Re: *Timex M515 Heart Rate Monitor – Class 2 Permissive Change*
Subj: *Description of Changes*
Date: *December 10, 2003*

*John Davino
Timex Corporation
555 Christian Road
Middlebury, CT 06762*

I. Front End Circuit Changes

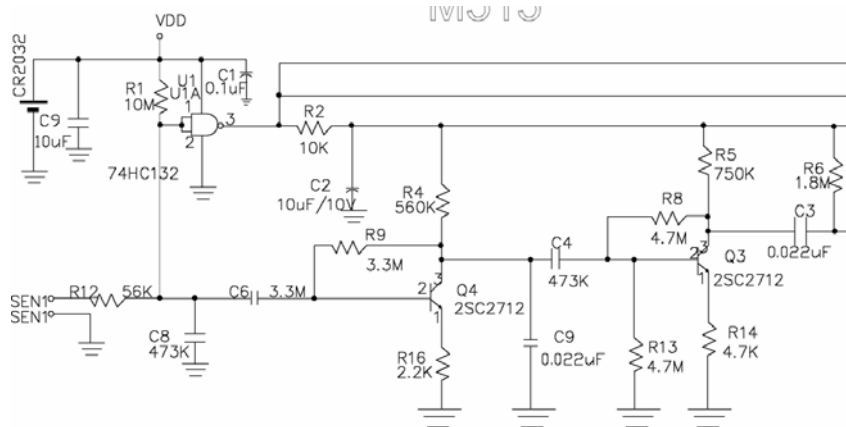
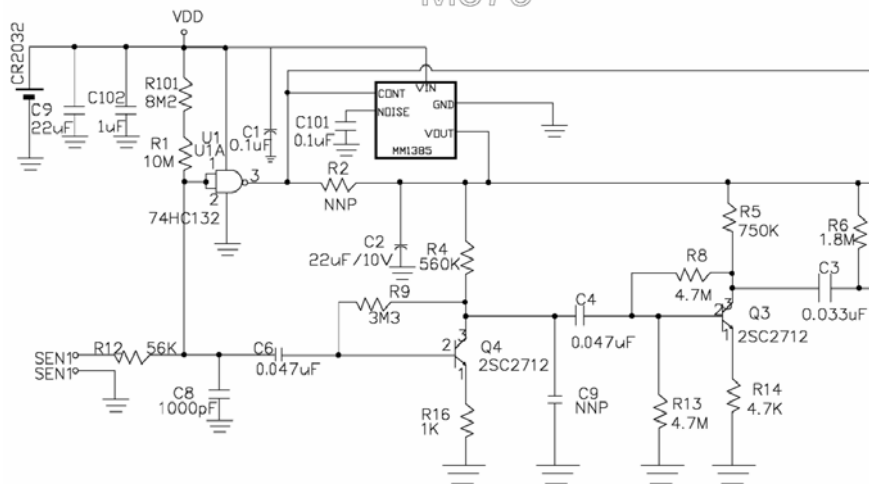
Changes were made in the front-end circuit, used to pickup an electrical heart beat signal from a person's chest, in order to reduce noise and to provide a regulated supply voltage. Component changes were as follows:

1. Increase the C9 from 10uF to 22uF in Vdd.
2. Add C102 1uF in Vdd.
3. A LDO MM1385 is added to supply 2.7V for the pickup circuit.
4. Reduce C8 from 0.047uF to 1000pF.
5. Change R16 from 2K2 to 1K.
6. Remove C9 0.022uF.
7. Change C3 from 0.022uF for 0.047uF.
8. Change R9 from 3M3 to 5M6.
9. Remove R2.

I. RF Circuit Changes

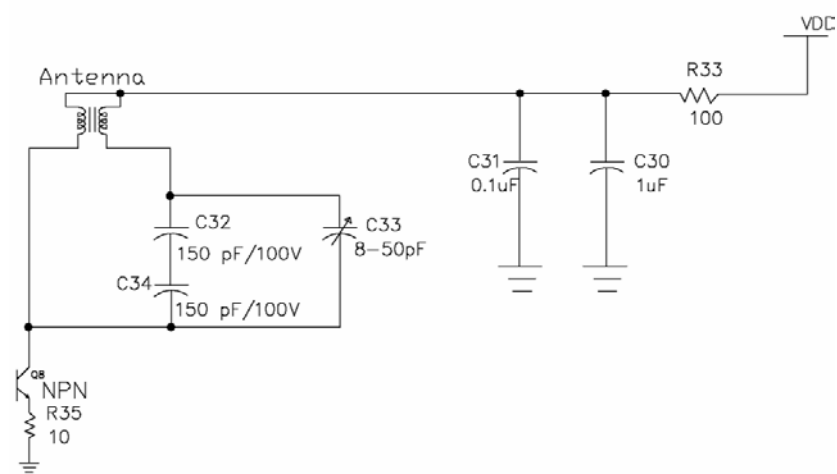
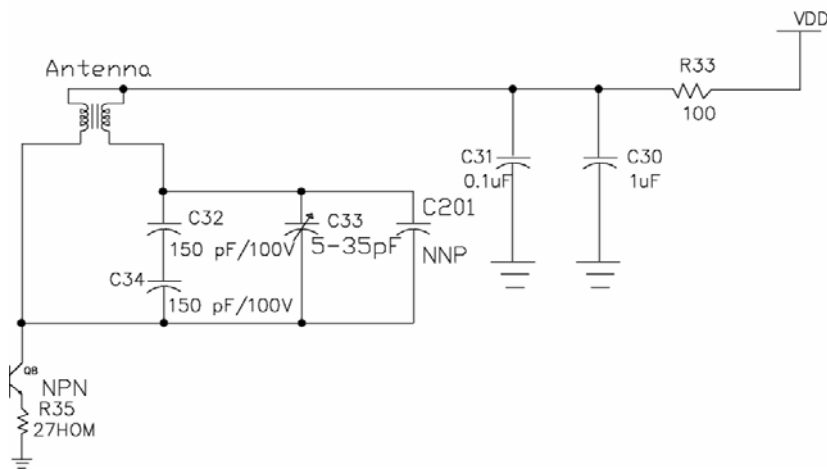
Minor changes were made in the RF Circuit to improve tuning. Component changes were as follows:

1. Change the resistor R35 from 10 ohm to 27 ohm.
2. Change the trimmer C33 from 8-50pF to 5-35pF.
3. Add the capacitor C201 for tuning.
